# CAA Operational Assessment

<b>Title of airspace change proposal</b>	Installation of Engineered Material Arrestor System (EMAS) to enhance safety
<b>Change sponsor</b>	London City Airport
<b>Project no.</b>	ACP-2022-090
<b>SARG project leader</b>	
<i>Case study commencement date</i>	01 March 2023
<i>Case study report as at</i>	16 March 2023

Figure A1-1. Standard EMAS Installation Provides a Level Of Safety That is Equivalent to a Standard Runway Safety Area (RSA).

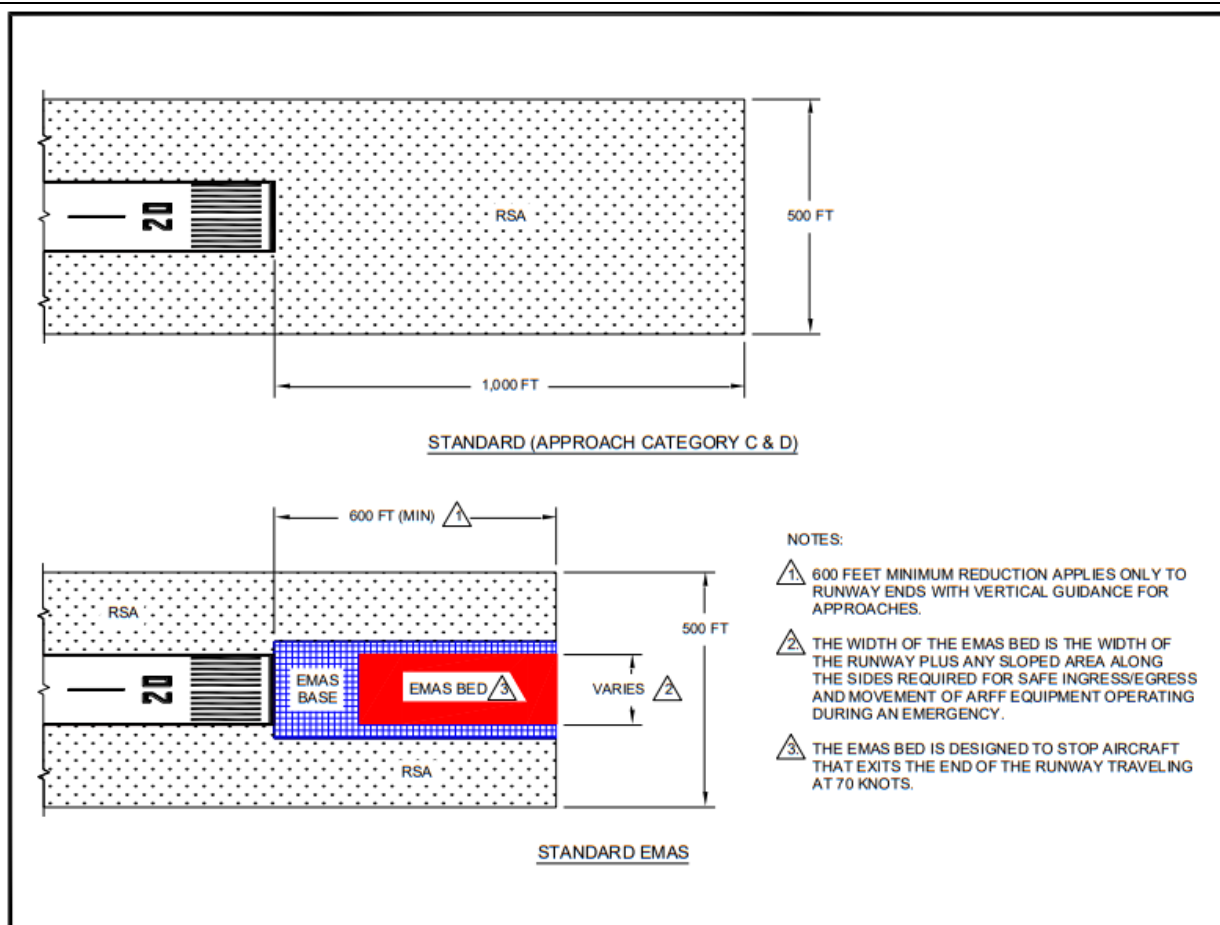
Details of the EMAS locations and positions of the proposed new runway threshold positions have not yet been received.

Diagrams below show JB assumptions (16/02/2023)
